SERVICETEKNOTES

Published by Tektronix Service
Administrative Support

TABLE OF CONTENTS

DC510/DC5010 INTERMITTENT OPERATION

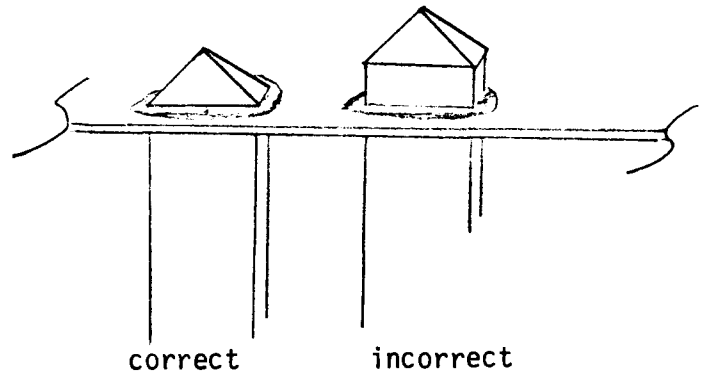
Intermittent operation of the counter can result when the pins of J1102 (A12) work loose at P1102 on the A18 auxiliary board. Manufacturing, on some instruments, failed to solder the pins of J1102 correctly to the board. The illustration shows correct positioning of the pins, with the pyramidal top just showing,

as compared to the incorrect positioning with too much of the shaft pushed through the board. The result of too much shaft pushed through the board is the pins of J1102 (A12) working away from their connection at P1102 of (A18) causing intermittent operation, and possibly a 313 serial path error.

Recommended repair of J1102 is replacement of the pins with a new set (pulling out and replacing the pins is easier than realigning the old pins).

Modifications:

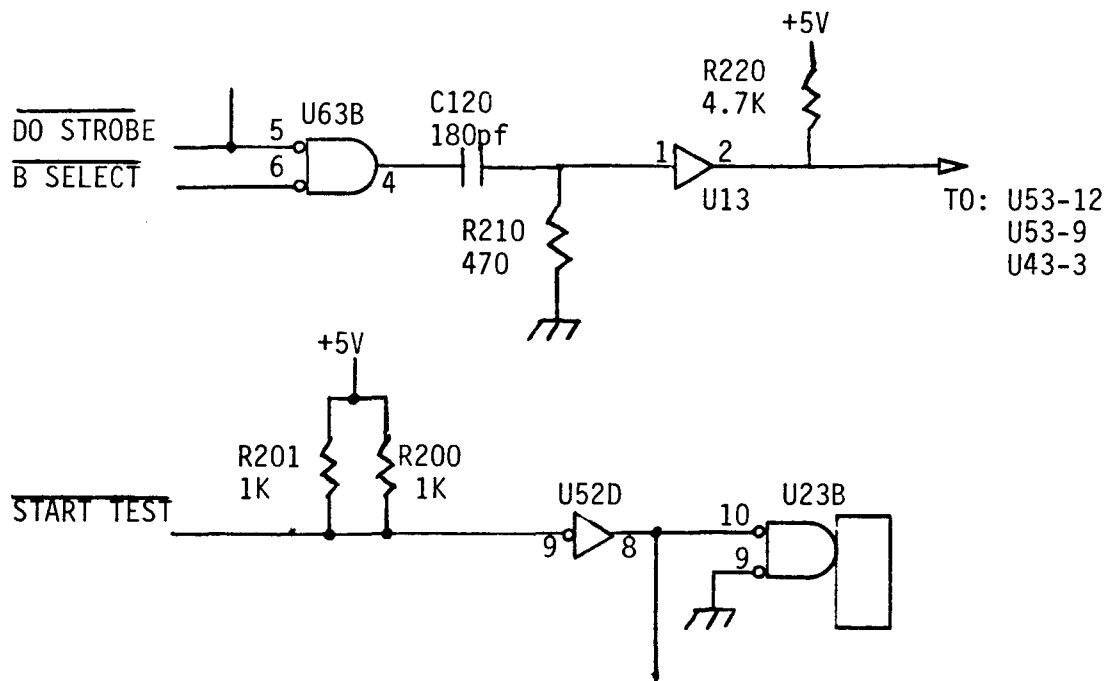
Modification M46750 Corrects two TACPR100 problems.

1. X address information overwrites Y address information causing incorrect wafer placement when operating in the Option 658 mode.
2. The Test System will intermittently cycle to "INTEST" when the handler is powered off.

1. Cut run between U63 pin 4 and U53 pin 9.
2. Add capacitor C120 (180PF, 283-0641-00) between U63 pin 4 and U13 pin 1.
3. Add resistor R220 (4.7K, 315-0472-00) between U13 pin 14 and U13 pin 2.
4. Add resistor R210 (470 ohm, 315-0471-00) between U13 pin 7 and U13 pin 1.
5. Add wire (0.4 ft., stranded, 26AWG, 9-0, 300V, from U13 pin 2 to U43 pin 3.
6. Add wire strap from R200 pin 8 to R201 pin 8. Use same type wire as in Step 5.

STEP 1 through 5 will shorten the X and Y load signals to 80 NS eliminating the problem of data changing state during an enabled condition.

STEP 6 will lower the value of R200 to 500 ohms. This will raise the voltage level and increase the noise immunity eliminating the cycle to "INTEST" when the handler is powered off.

Figure A
Partial Schematic

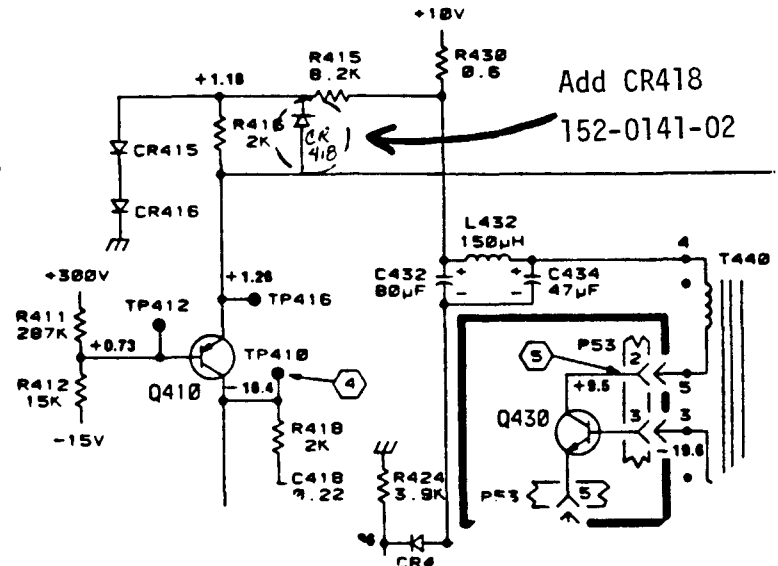
During high intensity operation, excessive beam current has caused Fuse F542 to beam.

Mod 49237 adds a catch diode (P/N 152-0141-02) to the circuit, and changes F542 to a 1 Amp fuse (F/N 159-0020-00). This will prevent failures of the fuse irregardless of where the screen intensity is set.

Add this mod (see Figure A) where this problem has occurred.

1450 SERIES SEMI-RIGID COAX

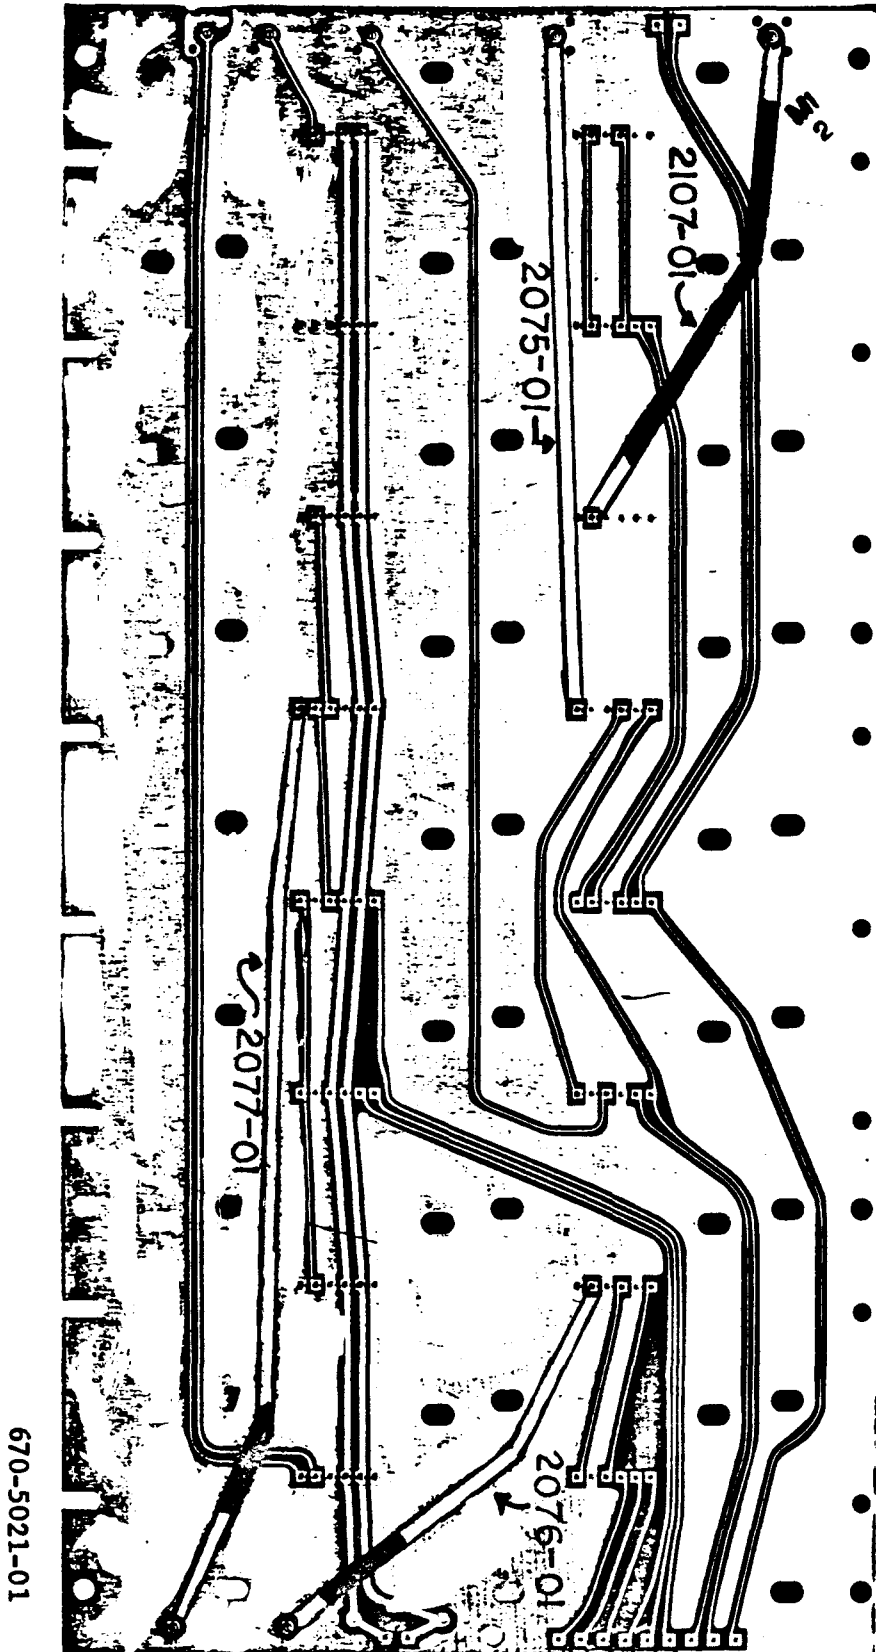
Mod 40160 changes the Phase Lock Interface board (670-5021-00) to a -01 version.

The main impact of this mod was to slightly lengthen the semi-rigid coaxial cables on the rear of the board, thereby insuring a better mechanical connection. The new cables are:

The replacement of these cables is illustrated in the attached diagram.

The new numbers should be used when replacing the corresponding cable on an earlier board.
